Public Comment Received for:

2339 Edgewater Way

(PLN2020-00014)

From: [Alexandra Hack](#)
To: [Community Development, SFDB Secretary](#)
Cc: [Tony Boughman](#); [Bradford Hack](#)
Subject: Concerns regarding PLN 2020-00014 (2339 Edgewater Way)
Date: Saturday, June 4, 2022 9:17:56 AM

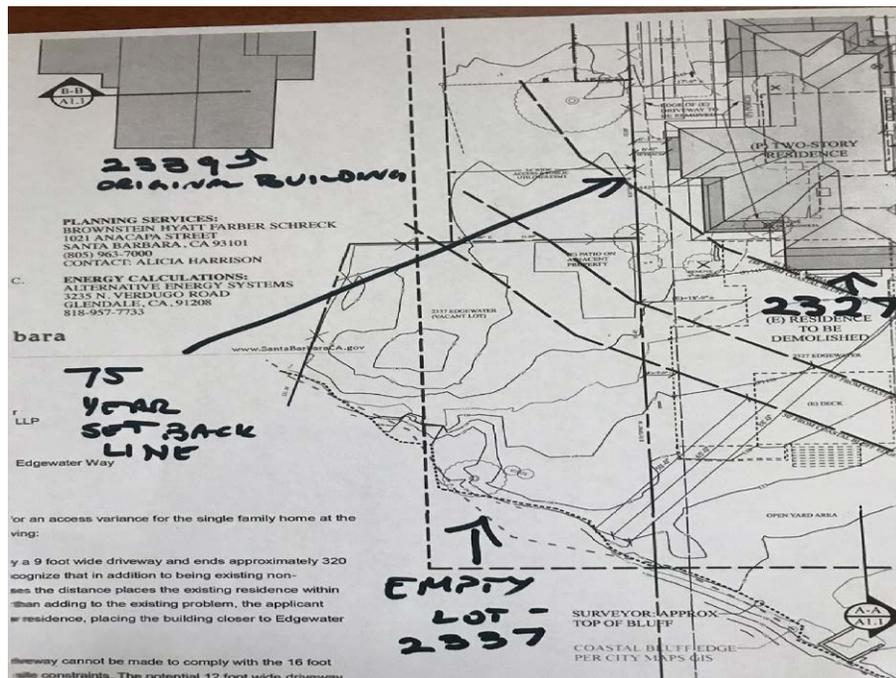
2. Bulk. For consideration of our neighbors, our house was brought down to a plate height of 24 feet. The south facing of 2339 (per the application), the lot is already a foot higher than our lot. Plus it appears there are steps up to the house on an elevated foundation of about 2 feet. This added to the 29 foot house height makes it look like a 32 foot height next to our 24 foot height limit. **This creates the bulk of a 32 foot high fairly monolithic building looking towards the east.**

Topographical runoff image:

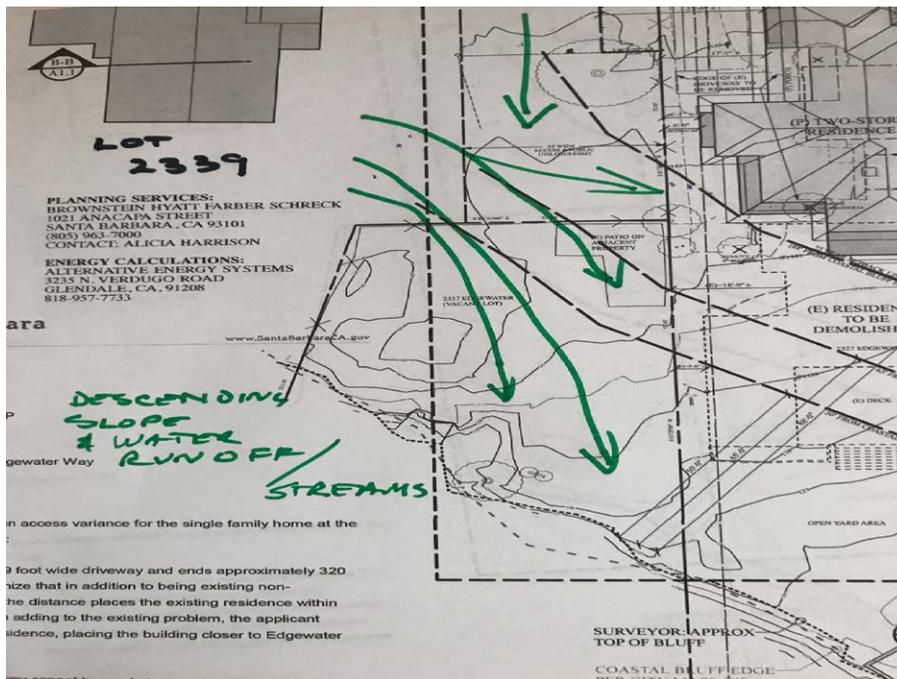
I have extreme concerns that the applicant wants to put a pool, a covered deck, pool equipment, all non absorbing materials, with added water run off in the corner of his lot. This is all in front of the 75 year set back, **all draining onto my lot and causing constant and potentially catastrophic erosion of the cliff edge.**

This corner of the Applicant's property, in every rainstorm, creates a stream and run off running down in multiple places across all of my property and over the cliff edge. This project proposes hard surfaces and vast amounts of water on an elevated surface. What happens when the pool overflows, when there is added run off from the deck and roof, when the spa leaks, or when the pool cracks in an earthquake or landslide due to it being built in front of the unstable 75 year set back line? **This will exacerbate erosion of an already environmentally sensitive area.**

Due to the location of the pool, the back flow from the pool equipment drains directly onto our site. This is in addition to the extra run off from the bulk of the house and other hardscape.

All this water flows down hill and onto our property causing more erosion (see geology study pictures above and actual pictures of present overflow below).
Per city letter dated 2018: “Archeologist should be made aware that the project site has a very high erosion and landslide potential”. Their own geotechnical report from Earth systems Pacific revised August 2022 states on page 16: “water should not be allowed to pond anywhere on the pad, nor should water be allowed to flow over the top of adjacent descending slope/ bluff top.”
